Suspension of Unit 3 PCV gas control system at Fukushima Daiichi Nuclear Power Station due to partial pipe replacement with steel pipe and control panel modification

January 28, 2013

Tokyo Electric Power Company

Duct to be replaced with steel pipe

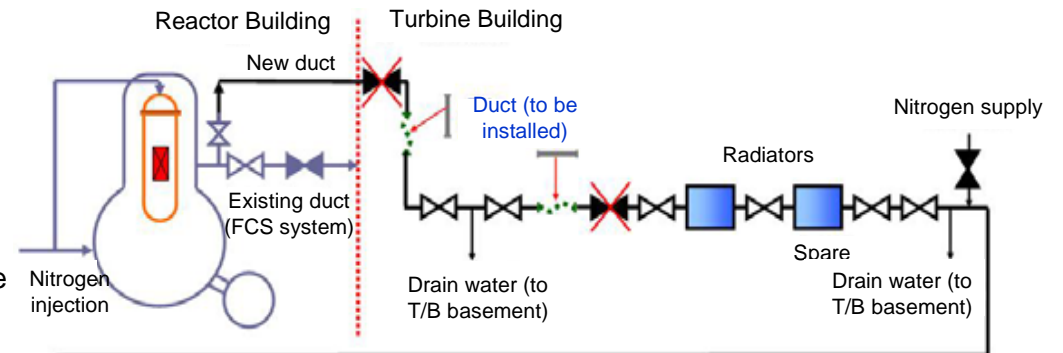
The area where duct hose is currently used will be replaced with steel pipe.

Current condition: Duct hose is used in 3 locations on the first floor of the Turbine Building which are susceptible to damage.

Countermeasure: As for 2 out of 3 locations (at the doorway of the feeding water heater room) where workers can access easily and are more susceptible to damage, the duct will be replaced with steel pipe and the layout will be changed.

* The work will not be done for the second floor of the Turbine Building as the radiation dose is high and workers do not enter the area often.

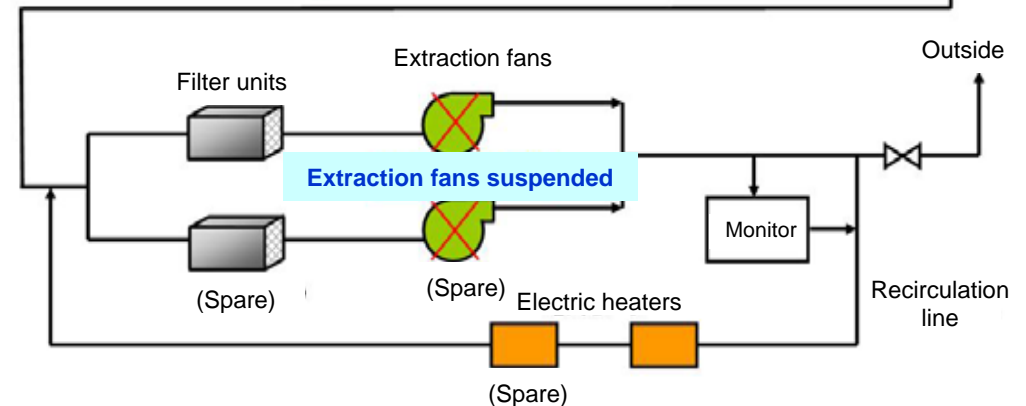
A function to send alarm to the Main Anti-earthquake Building in the case that both extraction fans are suspended has been added.

Current condition: There is no alarm function to be activated when both extraction fans are suspended due to incorrect operation, etc.

Countermeasure: An alarm display “both extraction fans suspended” sent to the Main Anti-earthquake Building has been added. The alarm is also displayed on the control panel at the site.
